LAKE PONTCHARTRAIN, LA.
AND VICINITY

DESIGN MEMORANDUM NO. 19
GENERAL DESIGN

ORLEANS AVENUE OUTFALL CANAL

ENGINEERING CORRESPONDENCE LOG

SHEET NUMBER 7 OF

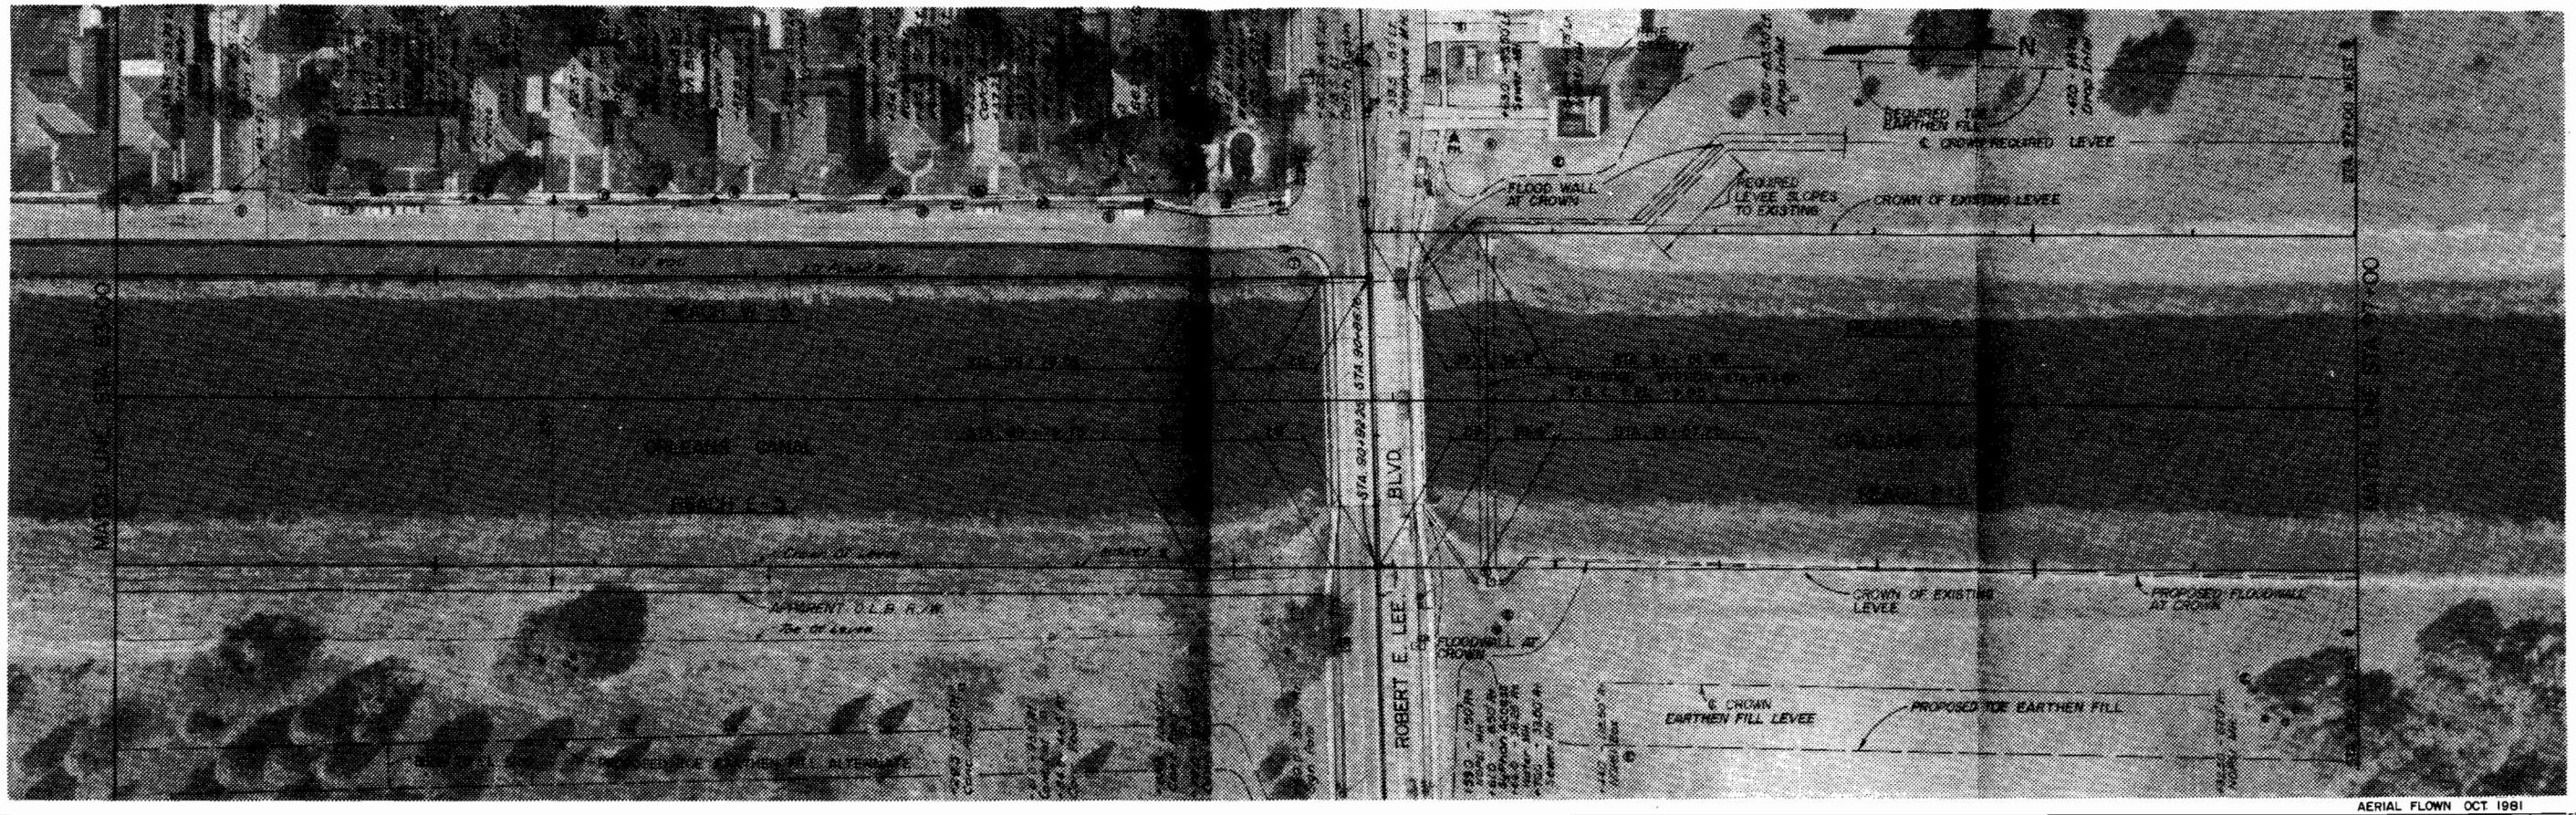
1. Sheet 7. "End West B/L" should be "End East B/L".

SHEET NUMBER 8 OF

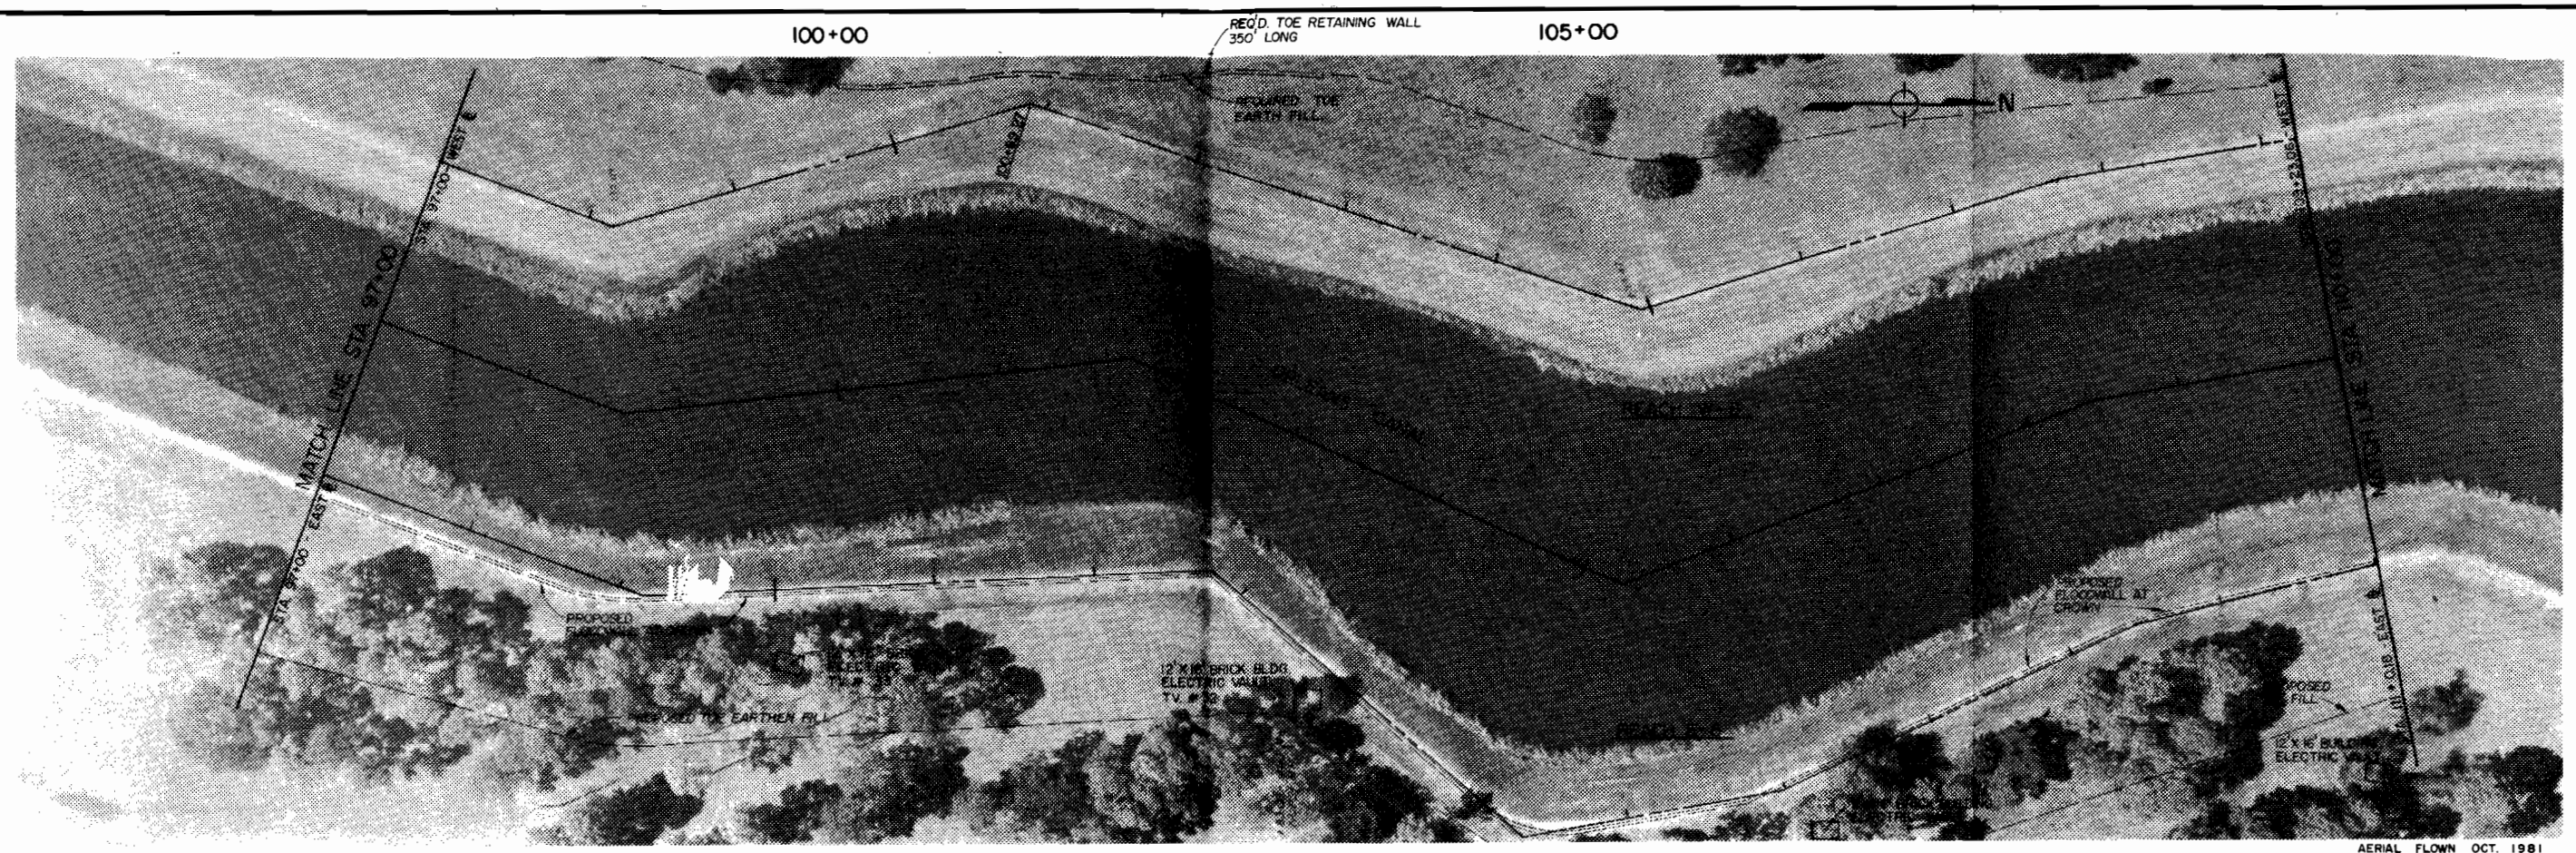
2. Sheet 8. There is no note following the number "1" under "Notes".

JOB No 1006
SCALE HORIZ. 1" = 50' VERT. 1" = 10'
SHEET NUMBER 9 OF

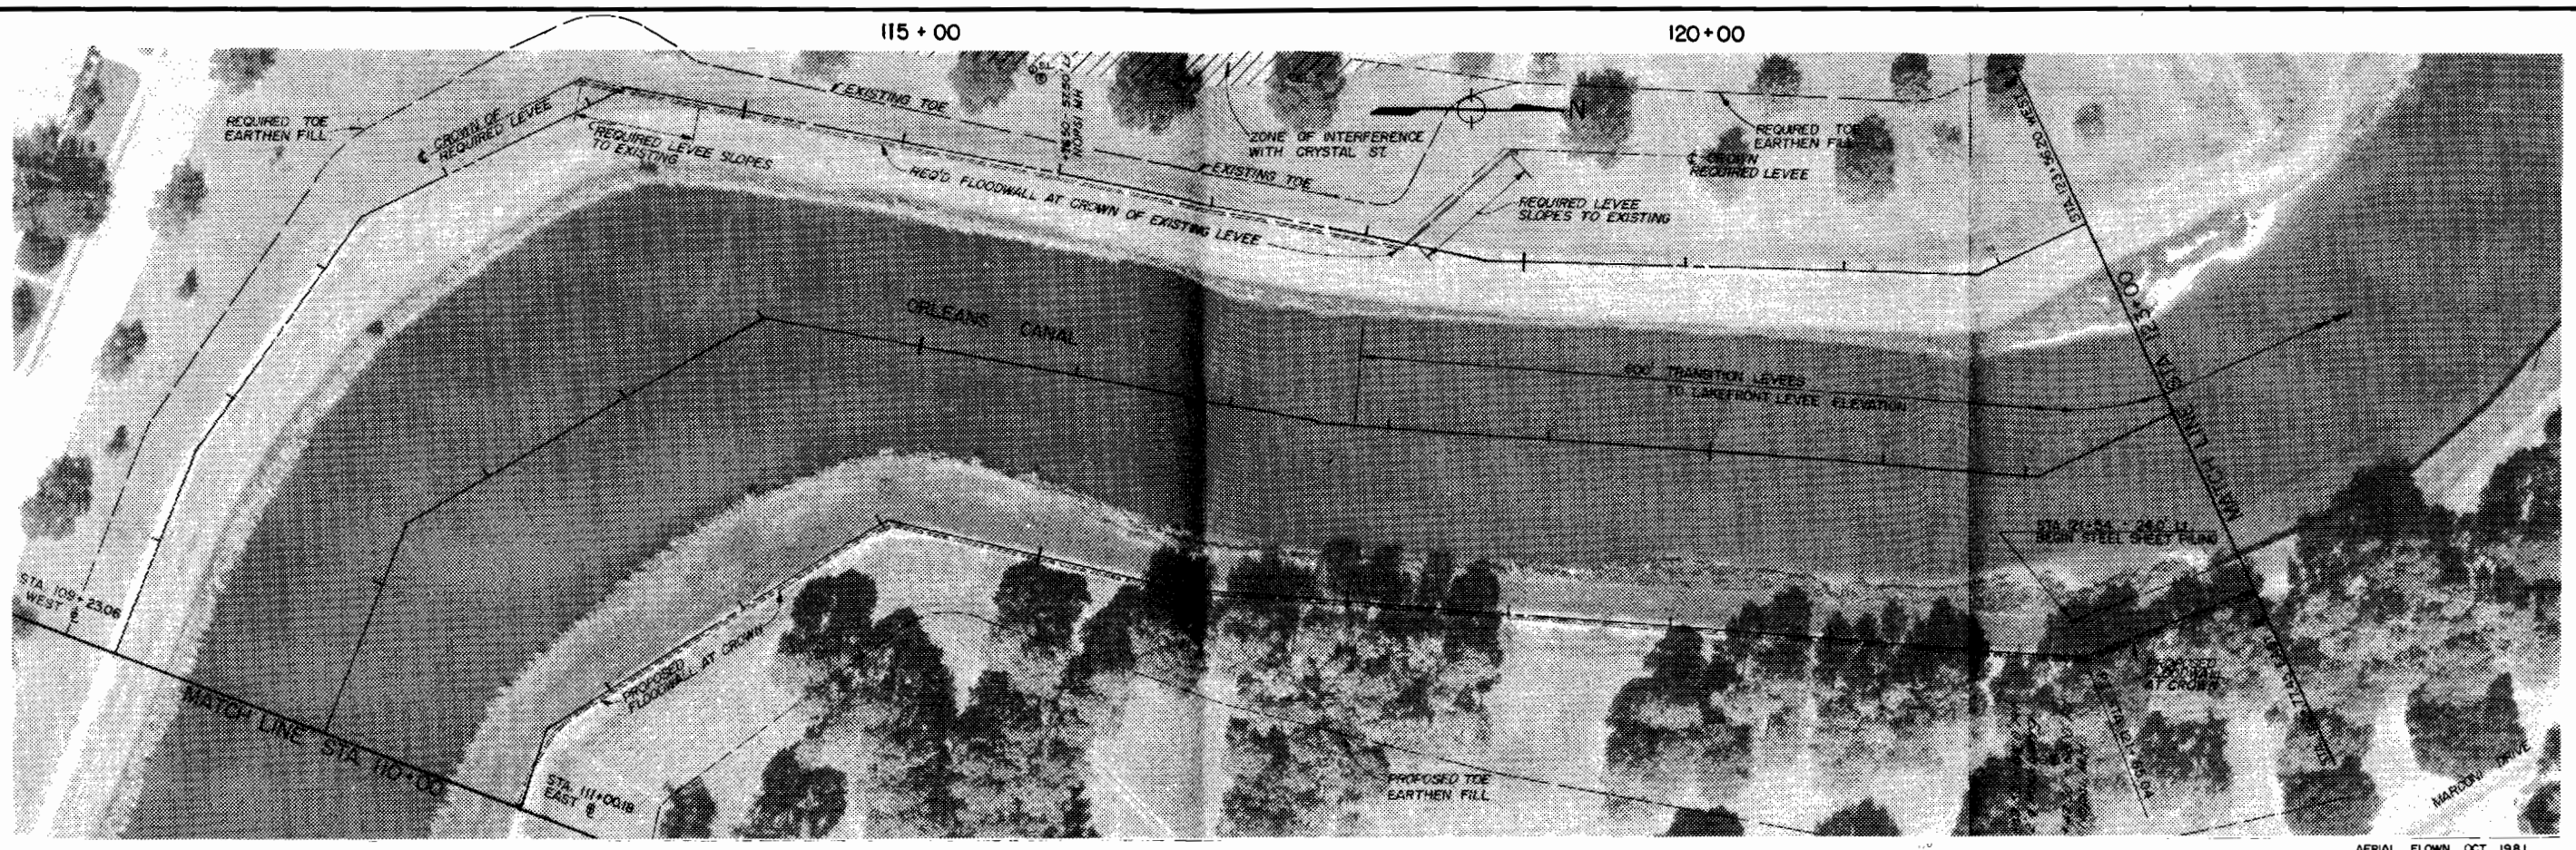
3. Sheet 9. The toe of the enlarged west levee is shown extending into the canal approximately between sta. 99+10 and sta. 101+10. The levee stability analysis must be revised since the levee fill cannot be semicompacted under water.

Comment No. 3 - A new section has been developed for the condition where levee toe extends into the canal on Sheet Nine (9). See Typical Section Sheet 15 and Eustis Enclosure 11, transmitted under separate cover dated October 6, 1987.
